**Consultation Response from Mark Berry KC,  
Highways Development Management**

**2023/92966 Land to the rear of, 271, Cliffe Lane, Gomersal, Cleckheaton, BD19 4SB**

**Demolition of existing dwelling and erection of 97 dwellings including formation of a new access from Cliffe Lane, landscaping, public open space and all associated infrastructure and engineering works**

**Date Responded: 5-2-2025.**

Cul de sac serving plots 80 to 88 (Note plot numbering on the Loroc plan differs from the Sanderson plan)

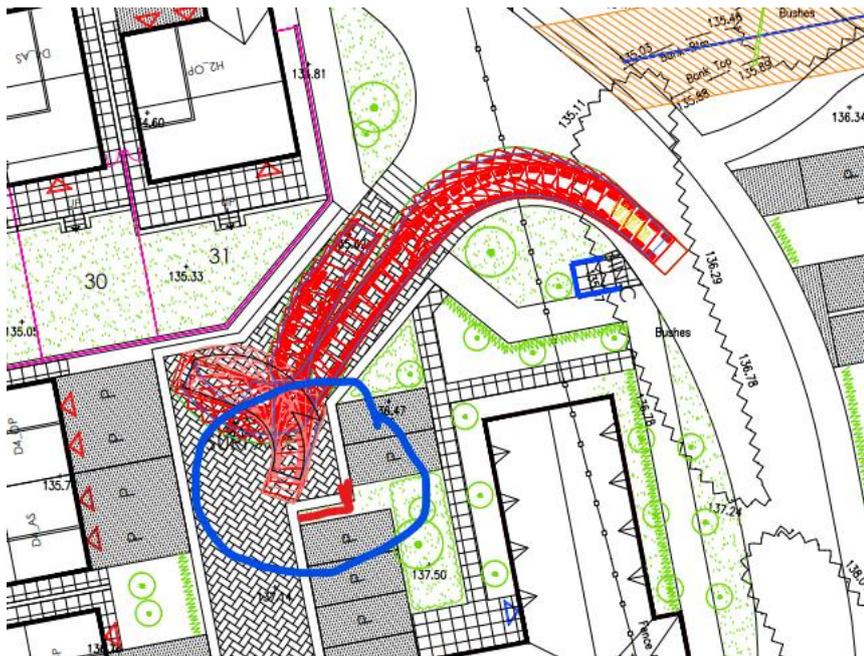
Visibility and forward visibility splays on Loroc plan number 1694-101 rev N don't correspond with Sandersons drawing number 152130 -003 rev A as follows:

The visibility splay at the junction with the spine road and the forward visibility splay across the frontage of plot 84 is not correctly shown.
